Comments

To: Public Service Commission of Utah

From: Utah Division of Public Utilities

Re: **Docket No. 25-035-22**, PacifiCorp's 2025 Integrated Resource Plan

Table 1 Load Forecast Change from 2025 Draft IRP to 2025 System IRP (West Region)

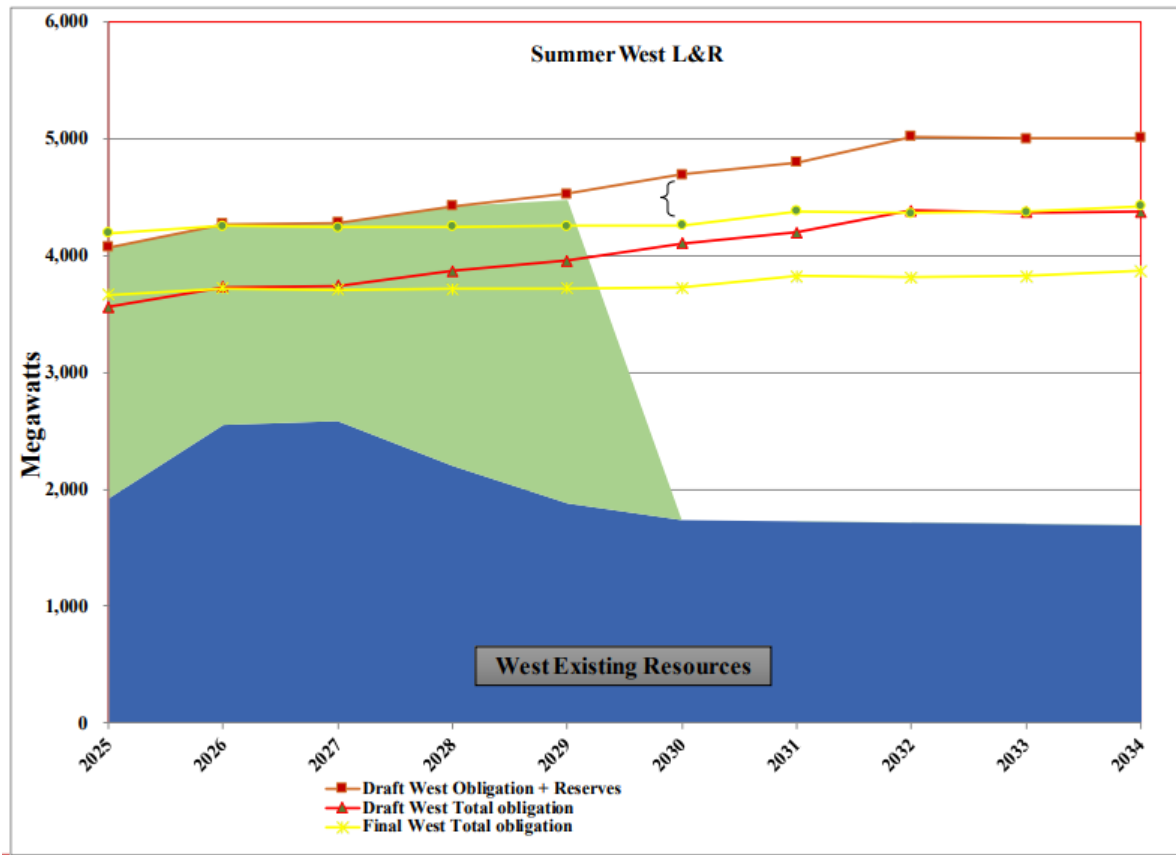
These refinements and enhancements had a large effect on some inputs. One slide depicted the new load forecast for the western portion of PacifiCorp as follows:²⁴

Some of these changes appeared to be in response to stakeholder input, but most of them were apparently “enhancements” and “refinements” that the Company made to the modeling process after the 2025 Draft IRP.
